CENTRAL LAND COUNCIL

**Submission to the Environmental Protection Agency of the
Northern Territory**

Rover 1 Project

Referral dated 18 August 2023 by Castile Resources Pty Ltd

Figure 2-1. Map of SOCS, SOBS, surface water features and land systems in the vicinity of the Project area

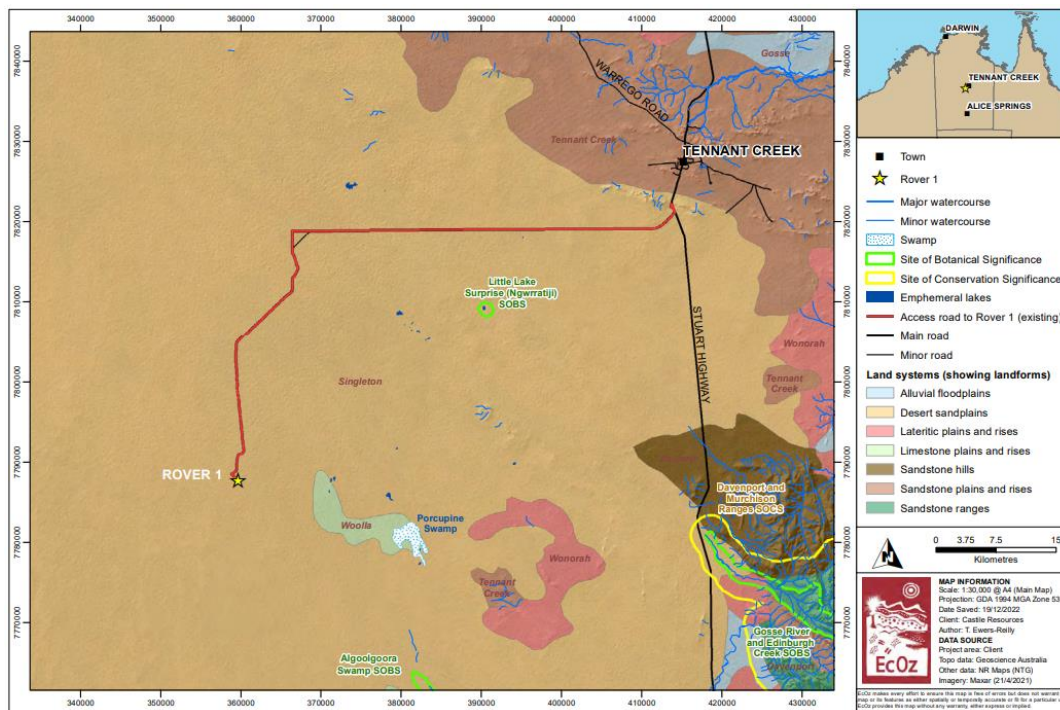
Comment - It shows Little Lake Surprise (a site of botanical significance) to the north east, Porcupine Swamp to the east and Alcoolgoora Swamp (another site of botanical significance) to the south. Monitoring sites are required to measure drawdown propagation the south-east to monitor any impacts to Alcoolgoora Swamp. Modelling does not suitable assess drawdown propagation and needs to as per previous comments. Where are any culturally significant sites?
